**Oakington & Westwick Parish Council Response to Planning Application
Northstowe 3A Ref: 20/02171/OUT**

Oakington and Westwick Parish Council Response to Planning Application Northstowe 3A

Oakington and Westwick PC having examined the Planning Application Northstowe 3 A REF: 20/02171/OUT, wish to raise the following objections and request the following planning conditions.

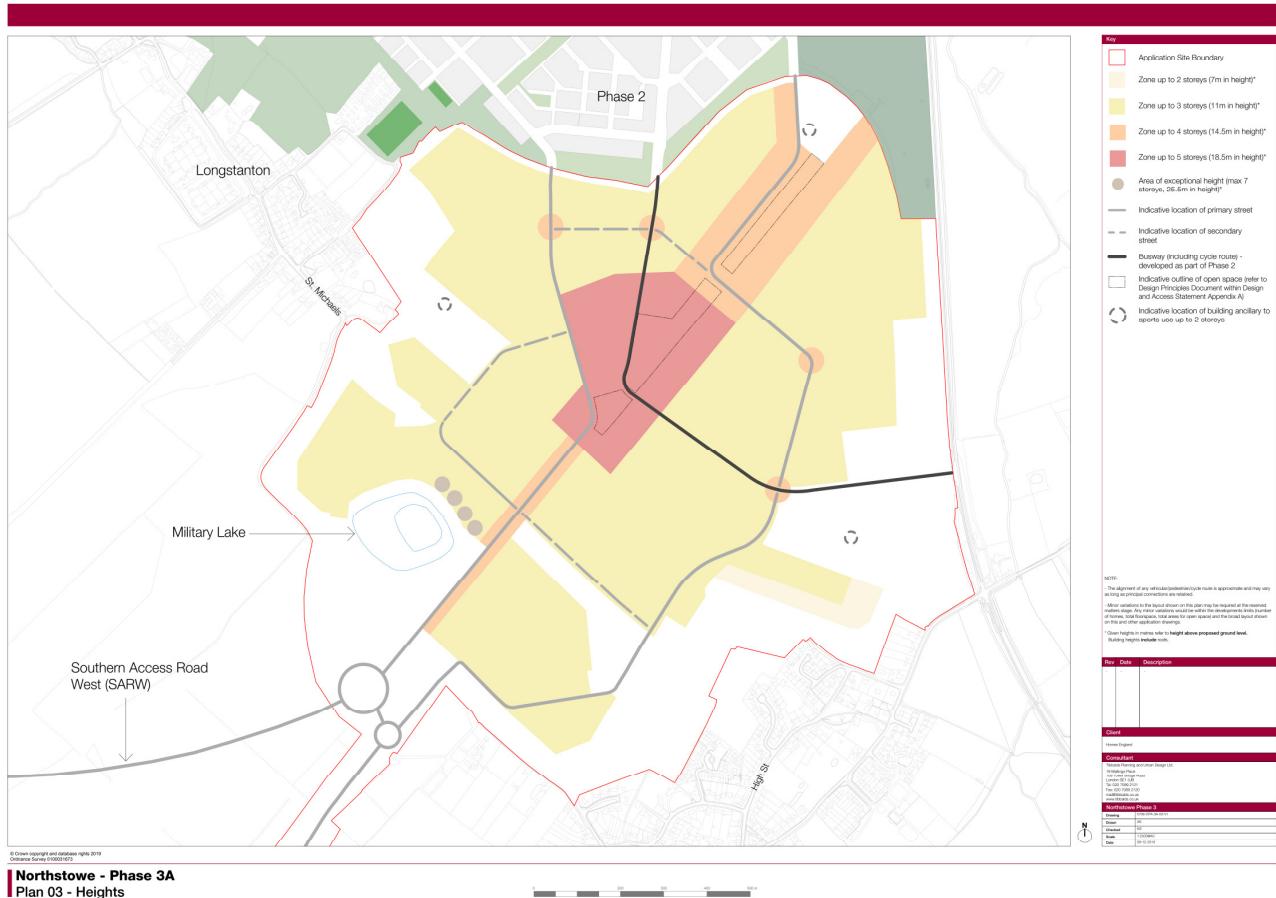
Further, Page 28 of the Planning Application makes the following claim:

The 'Oakington Edge' zone marked on Figure 6.28b in the DAS has been identified as the most sensitive area to height. Height restrictions of up to 2 storeys have been proposed here, which will be located behind substantial natural buffers afforded by the existing tree belts (NAAP NS/25).

However, the Building Height Plan (Ref document 5709 Northstowe_Parameter Plan_3A_Heights_09-12-2019) contradicts this. See Map 2 on page 20.

Rather, the planning application reveals that:

- (i) to the SE of the site, bordering Church View and Mill Rd. The large majority of housing of the proposed block of properties here are three storeys, with a small section of two storey buildings, which allow the developers to make the misleading claim above. The proposed block will, in fact, dominate a sensitive part of the village, particularly as they are located at a distance of 60 metres from the existing two storey housing. If there is to be any housing allowed, then a maximum height of two storeys is appropriate at all parts of this location.

- (ii) to the South West of the development, bordering Longstanton Rd/Lowbury Crescent. All housing in this area will be three storey, contrary to the statement above. These properties will be visible over the trees from much of northern Oakington. A maximum height of two storeys is appropriate at this location.

- (iii) there are proposals for seven storey buildings near the military lake on the west side of the site. Buildings of this height are completely inappropriate in the immediate vicinity of water park to the west of the site. These will dominate the skyline on a predominantly flat landscape and destroy the rural aspect of the development from the West. A maximum of three storey buildings are appropriate here.
